Docket Item # 22
BAR CASE # 2015-0269

ISSUE: New Construction: Building 3

APPLICANT: RTS Associates, LLC

LOCATION: 2 Duke Street

OVERALL ELEVATIONS

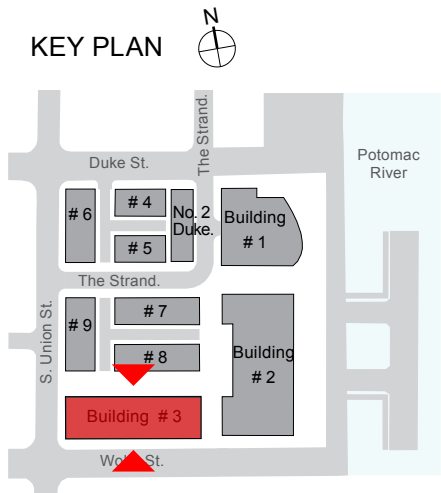
1. Make the hyphen between buildings 3 and 3a stronger and more distinct;
2. Continue to differentiate building 3a at the eastern end from building 3;
3. Refine the stone work on the door surrounds on the north elevation; and
4. Consider adding visual and physical variety to the roofline.

5. Make the hyphen between buildings 3 and 3A more distinct;
6. Continue to differentiate the eastern end of the building; and
7. Refine the stone work on the door surrounds on the north elevation

As the BAR noted at the last hearing, a fully expressed hyphen connecting the two elements of Building 3 will also distinguish the two building segments and provide additional visual interest. Carrying the dark grey slate color used on the fifth story of the western element down through the hyphen would visually recess the hyphen further and function as a break between the two building elements, suggesting the historic service alleys found throughout Old Town. The use of the dark grey color combined with large glass windows will make this hyphen a distinct element. The removal of the pronounced mullions could also visually mark this as a connector between the two elements while making the hyphen appear more transparent. It may, or may not, be necessary to carry this design idiom through on the north elevation of Building 3, where the break is less integral to the design.

The applicant has proposed a mix of stone and brick for the pilasters and surround on the north elevation. However, the use of field stone, like one would see on a historic Alexandria building's foundation, is not appropriate for pilasters and an entrance surround. The use of stone, conceptually, is architecturally appropriate and identifies the importance of the entrance but staff recommends that the doorways be surrounded by a dressed and tooled, cut stone.
